**ADDENDA****CONTRACT NUMBER 11-17-1  
PORT OF STOCKTON  
DOCK 12/13 REHABILITATION PROJECT**

ADDENDUM NO. 1

June 12, 2018

**PORT OF STOCKTON  
STOCKTON A #1 60 KV  
STOCKTON A 1101 12KV**

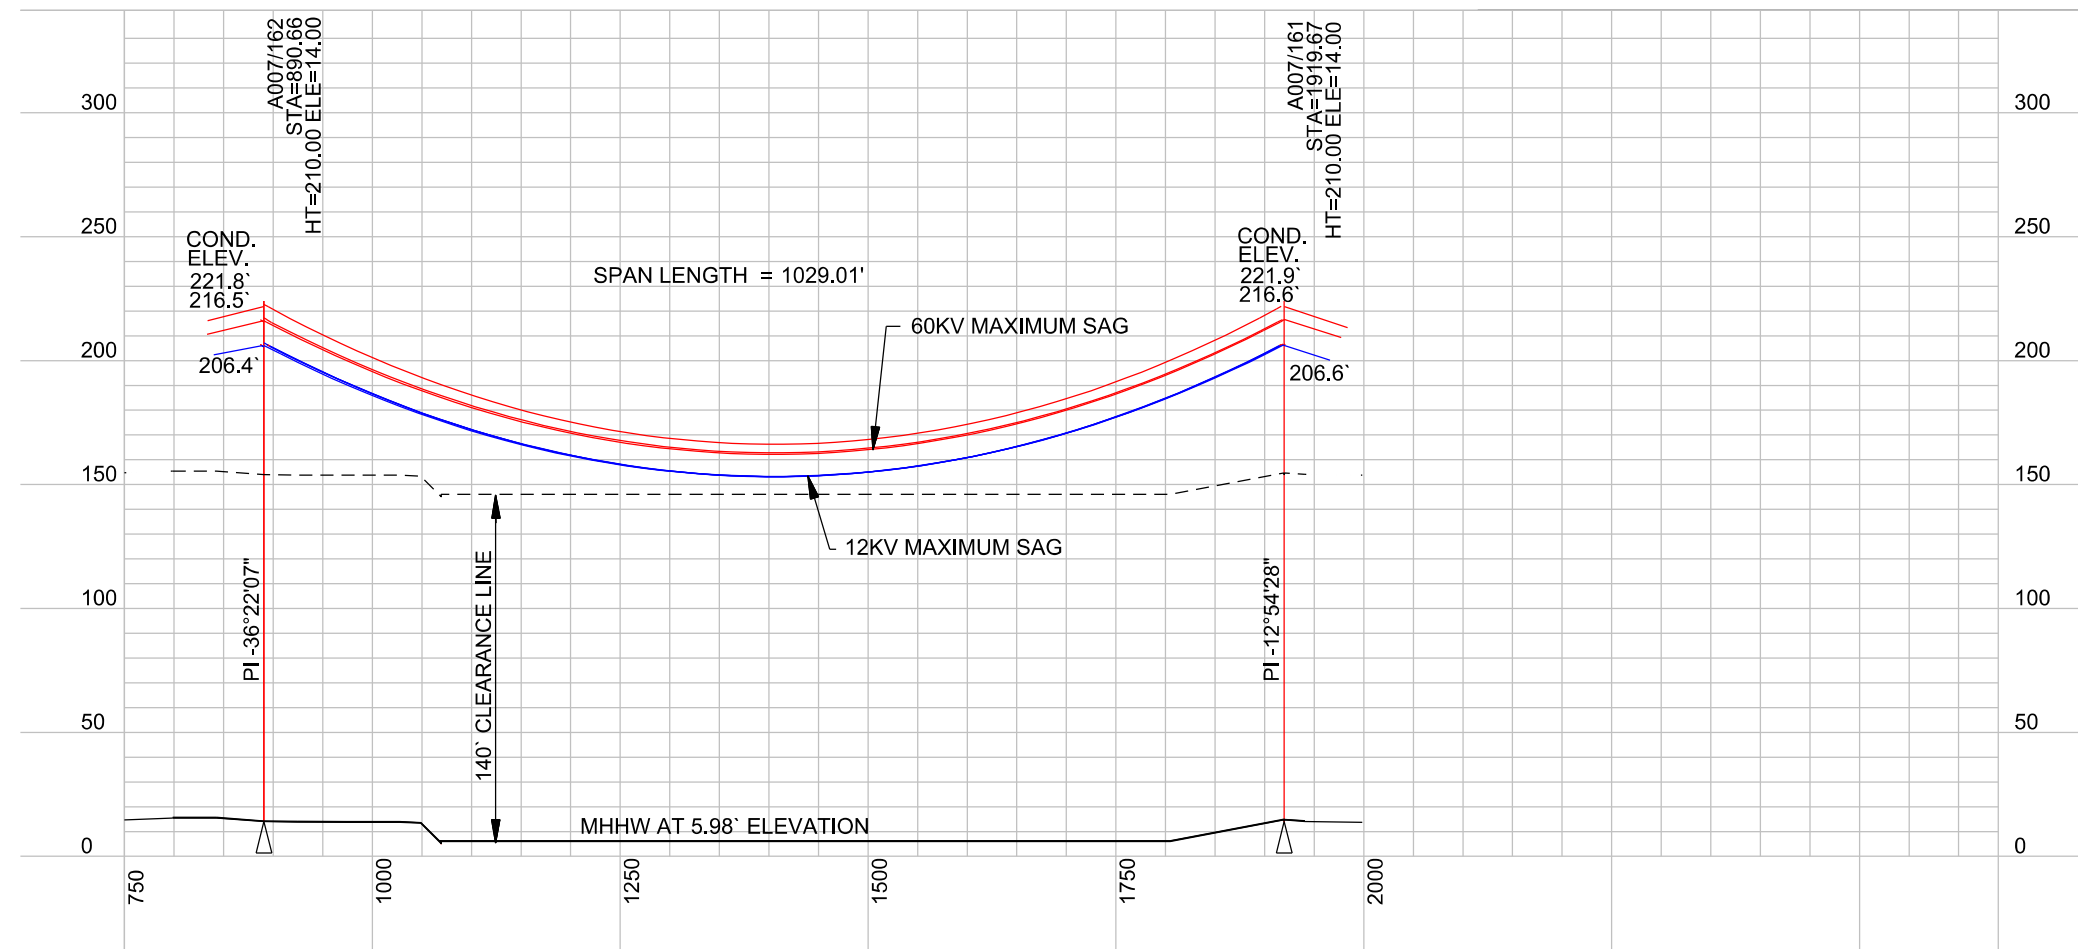
18. What is the catenary height of the overhead power lines near ED 11?

**ANSWER:** See attached Drawing SA-298 - Stockton A #1 60KV / A 1101 12KV
